**POST BID ADDENDUM NO. 03
LEGRANDE ELEMENTARY SCHOOL ADDITION AND RENOVATION
SCB PROJECT NO. 2210**

FROM: Sherman Carter Barnhart Architects
144 Turner Commons Drive, Suite 110
Lexington, Kentucky 40508

DATE: September 11, 2023

This Addendum consists of 50 pages / drawings.

1 ROOF PLAN - MECHANICAL NEW WORK
SCALE: 1/8" = 1'-0"

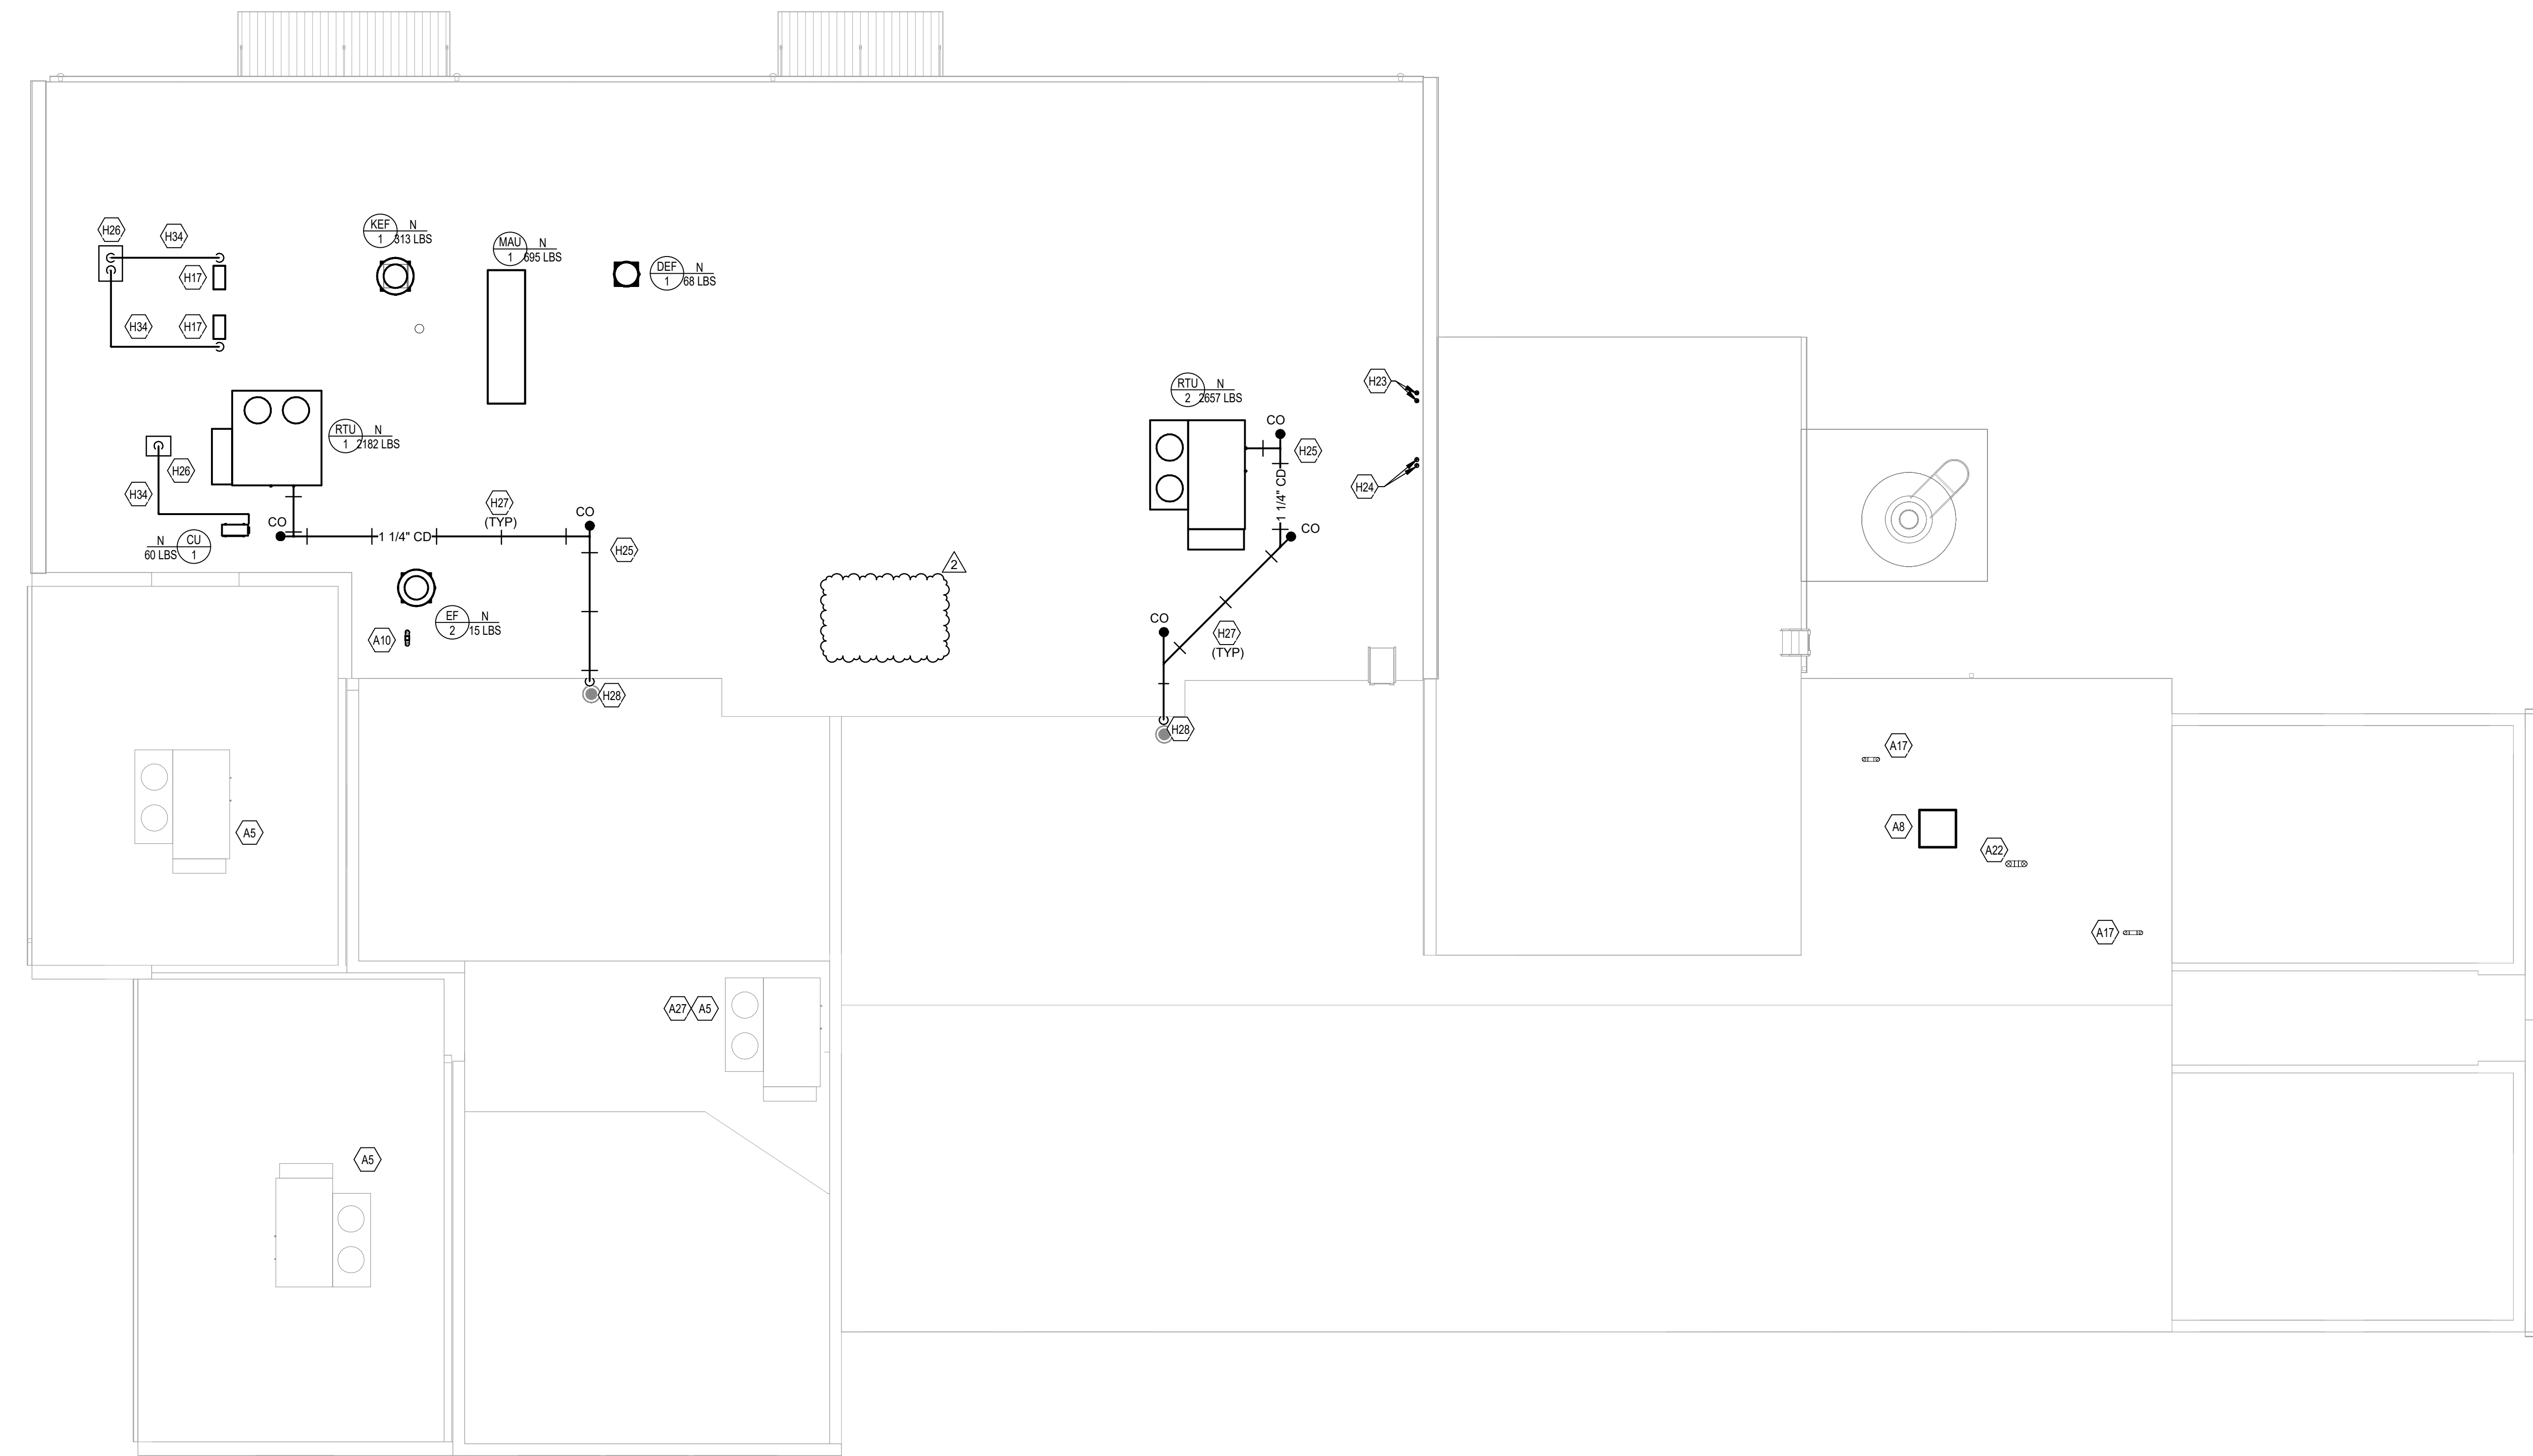
4. Sheet M3.2 – Roof Plan – Mechanical New Work
 - a. Removed EF-3.

1 FIRST FLOOR PLAN - ELECTRICAL DEMOLITION
SCALE: 1/8" = 1'-0"

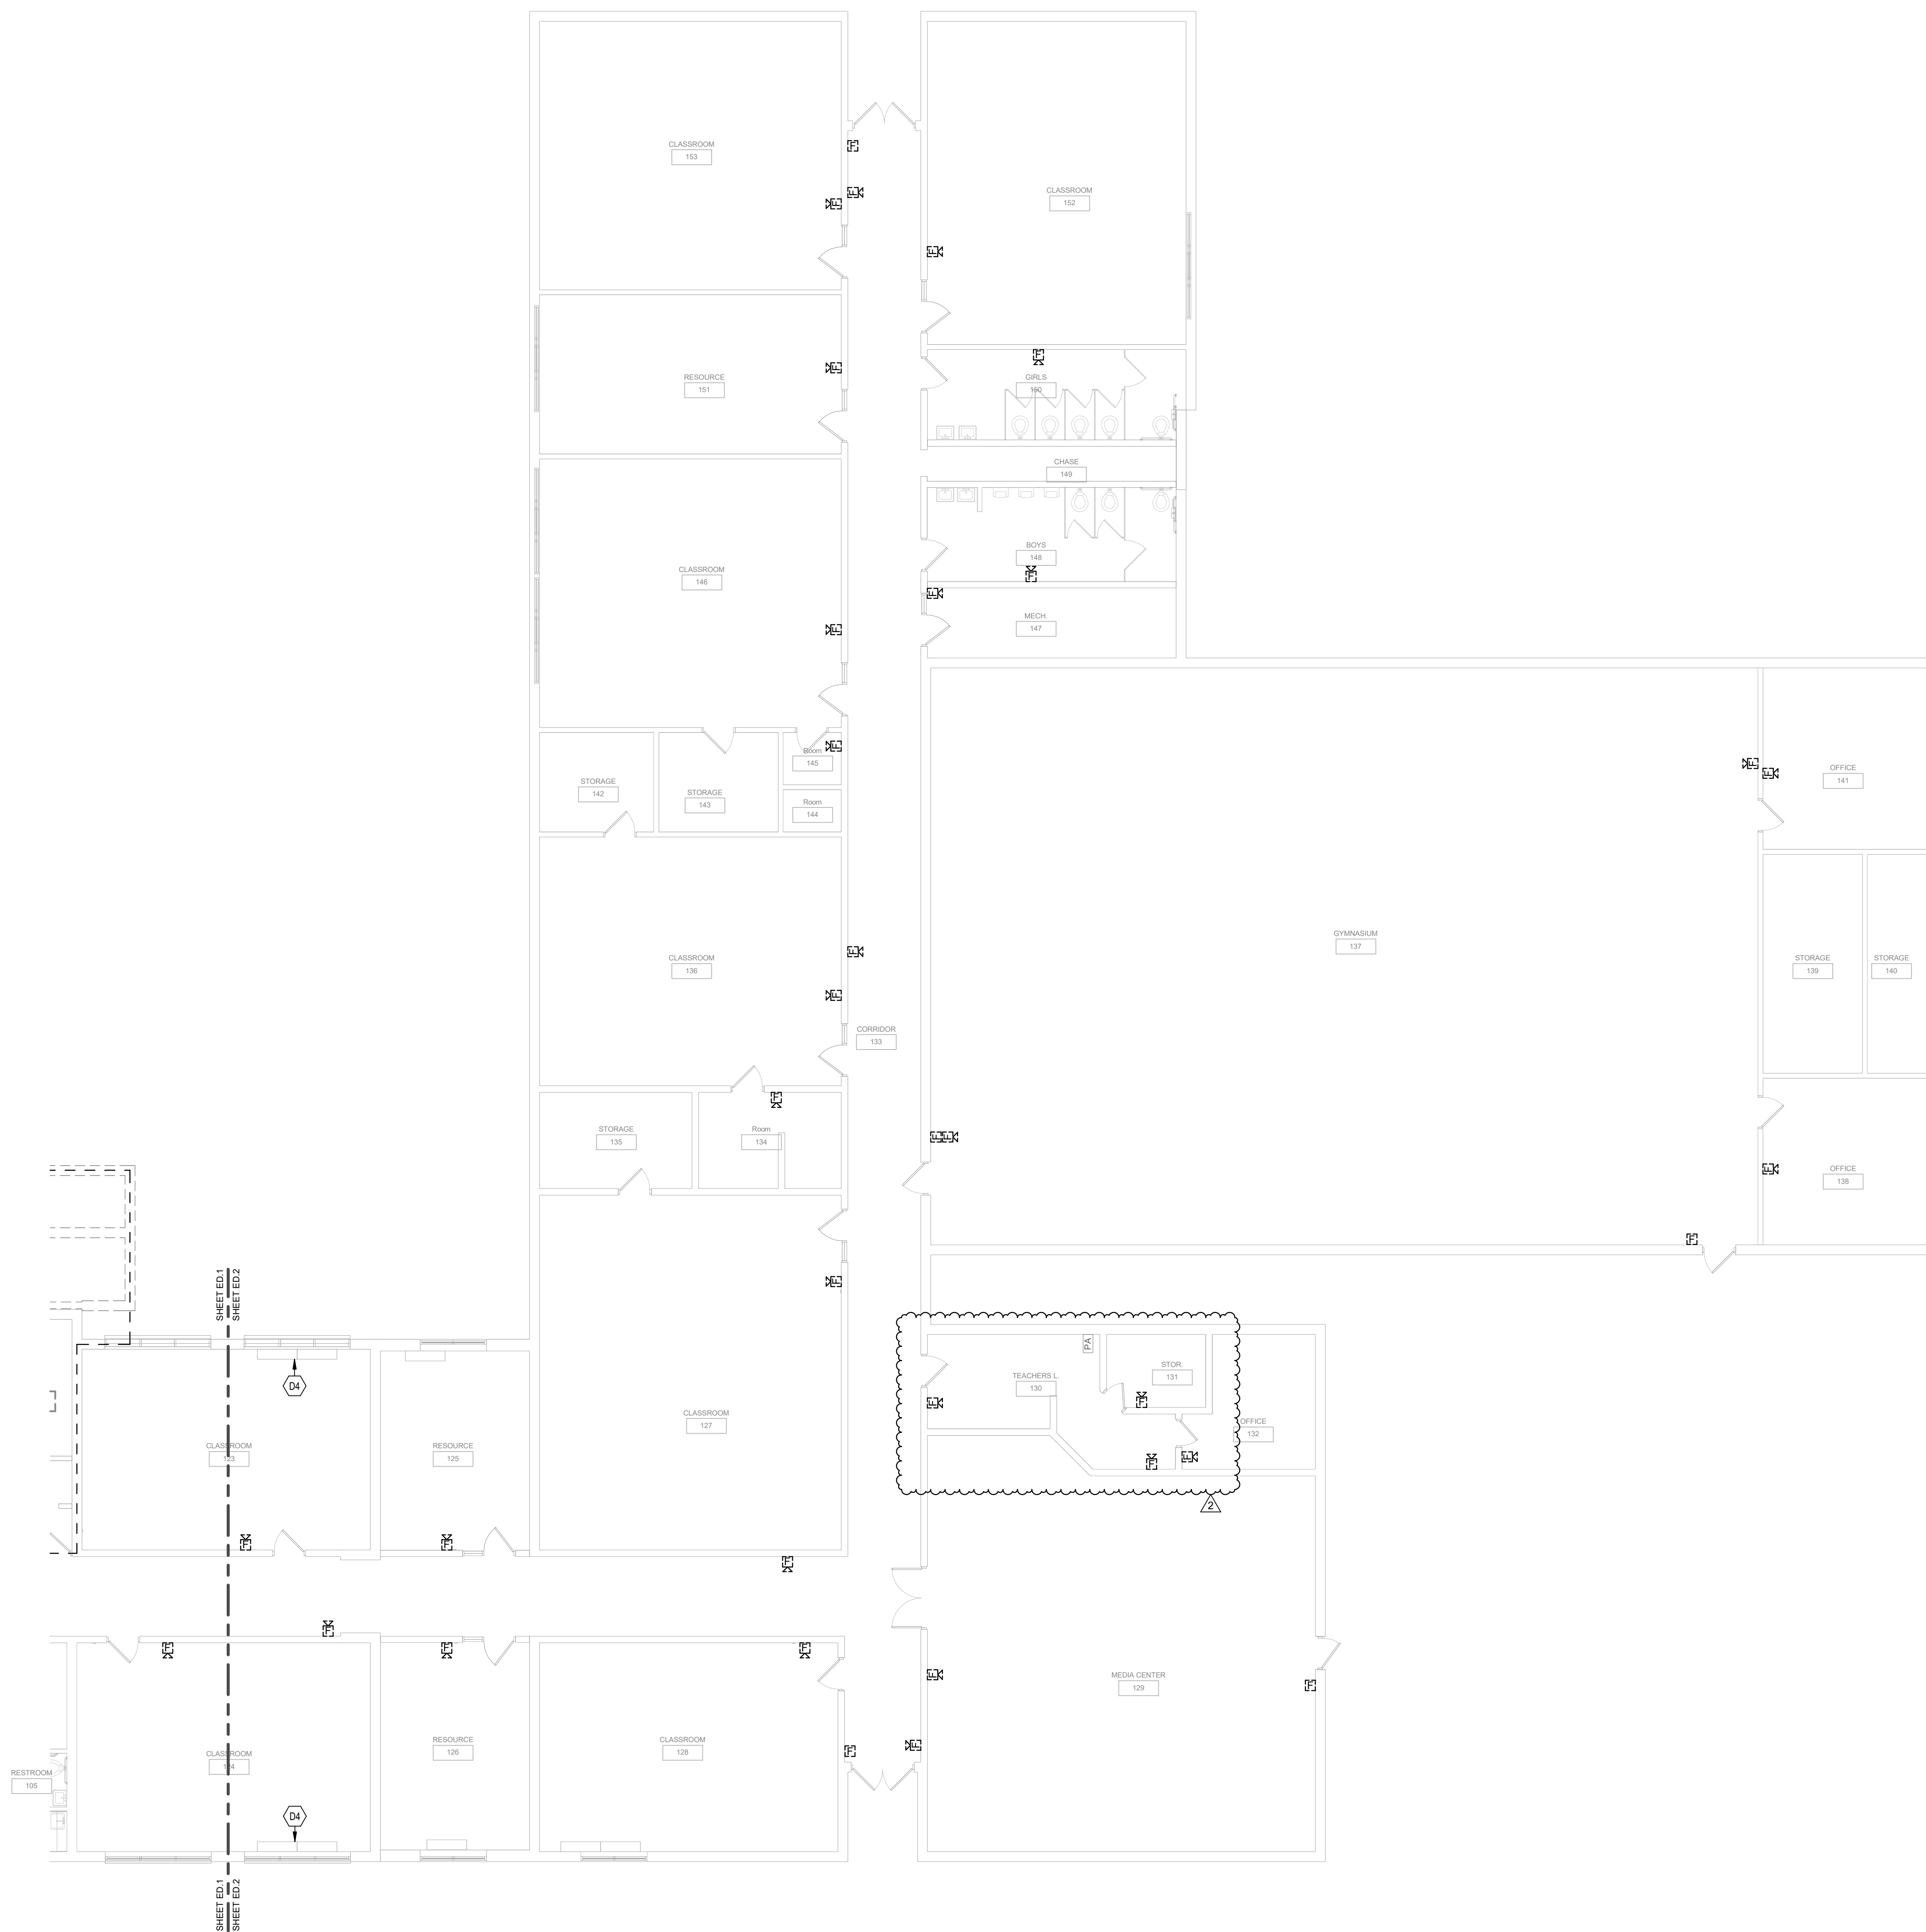
- 2. Sheet ED.1 – First Floor Plan – Electrical Demolition
 - a. Revised demolition scope in Restroom 115 and 116.
Add or Deduct: \$_____.
 - b. Revised demolition scope in existing admin area.
Add or Deduct: \$_____.

2 COMMUNICATIONS RISER DIAGRAM
NO SCALE

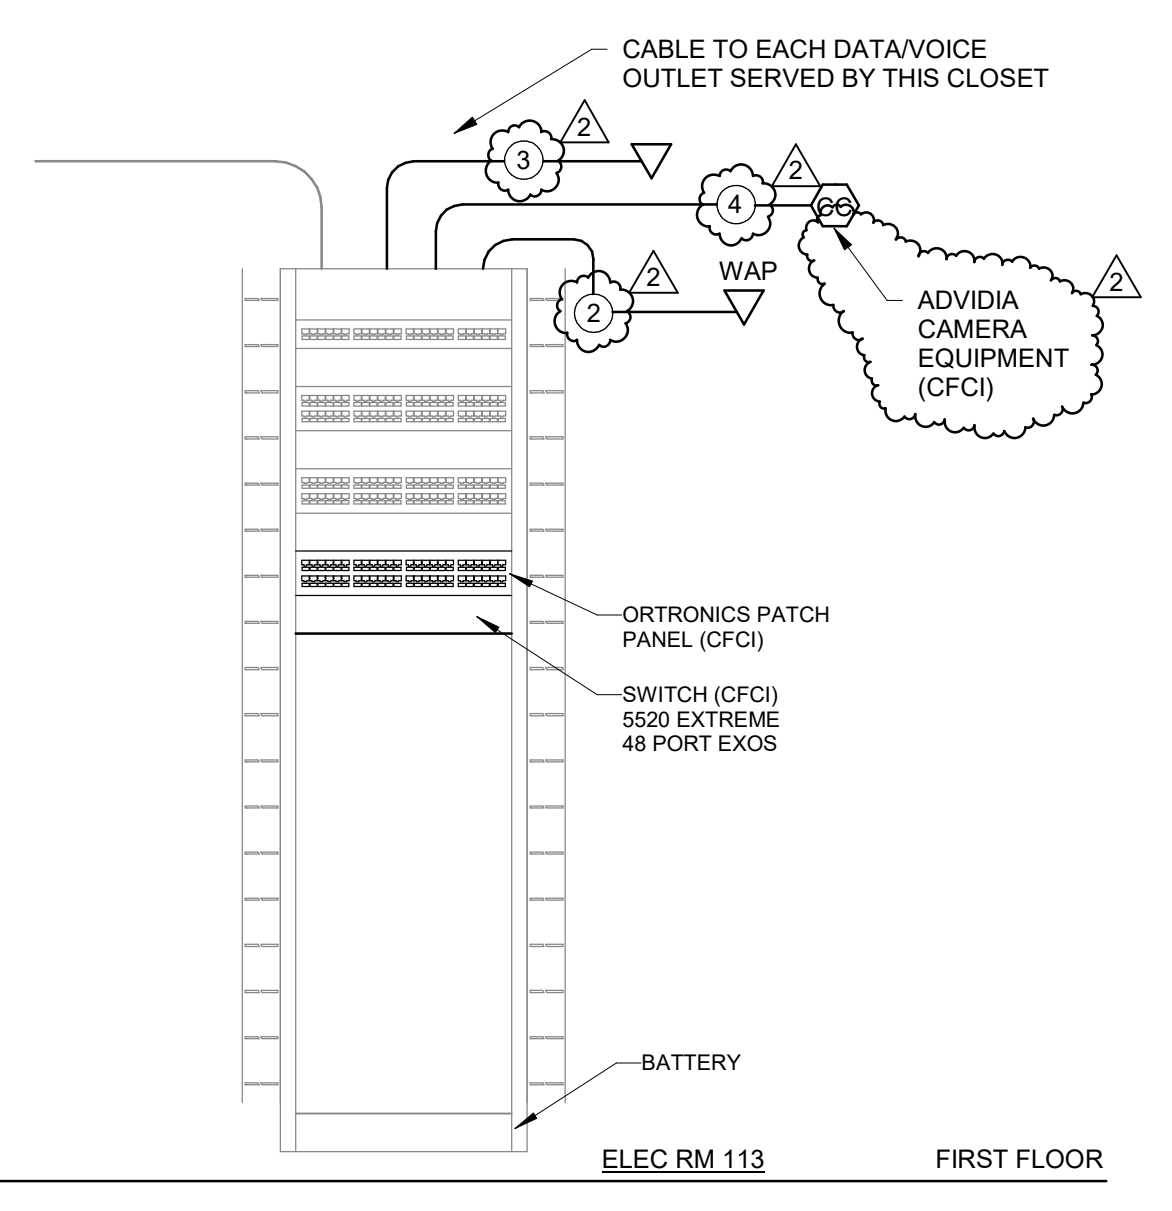
- a. Revised new work scope in existing admin area.
Add or Deduct: \$_____.
 - b. Revised Communications Riser Diagram.
Add or Deduct: \$_____.
 - c. Removed door hardware for double doors in Cafeteria 164.
Add or Deduct: \$_____.
